Working Party on the Transport of Dangerous Goods

**Proposals for amendments to annexes A and B of ADR:
construction and approval of vehicles**

Section 9.7.6 – Rear protection of vehicles

Transmitted by the Government of the United Kingdom*

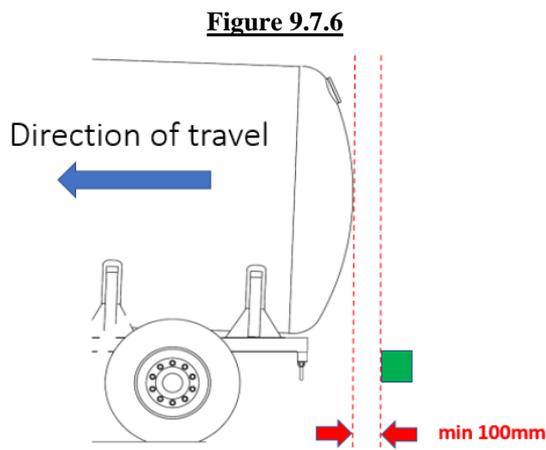
4. A 100 mm gap between the rearmost point of the tank and the foremost face of the bumper as shown in Figure 1 below, is beneficial from a tank protection perspective. Even in the most severe impact situations, such as a rear end collision from another heavy goods vehicle, this clearance is of benefit in helping ensure the tank is protected.

9. In ADR 9.7.6, amend the text after the heading to read as follows, deleted text struck through and new text in bold:

“A bumper sufficiently resistant to rear impact shall be fitted over the full width of the tank at the rear of the vehicle. There shall be a clearance of at least 100 mm between the rear wall of the tank ~~and the rear of the bumper (this clearance being measured from the rearmost point of the tank wall or from projecting fittings or accessories in contact with the substance being carried).~~ **(or of its projecting fittings in contact with the substance being carried) and the foremost face of the bumper facing the rear wall of the tank. This clearance shall be measured as specified in Figure 9.7.6.**

Vehicles with a tilting shell tank for the carriage of powdery or granular substances and a vacuum-operated waste tank with a tilting shell with rear discharge ~~for which the clearance of 100mm cannot be respected shall have a protective device do not require a bumper if the rear fittings of the shell are provided with a means of protection which protects the shell tank and the rear fittings in the same way~~ **man**ner as a bumper. **This protection shall have a section modulus of at least 20 cm³ and have a minimum clearance of 100 mm between the rear of the tank and the foremost part of the additional protection in the direction of travel.**

NOTE 3: For double wall tanks the rear of the tank shall be taken to be the rear of the outermost wall of the tank.”
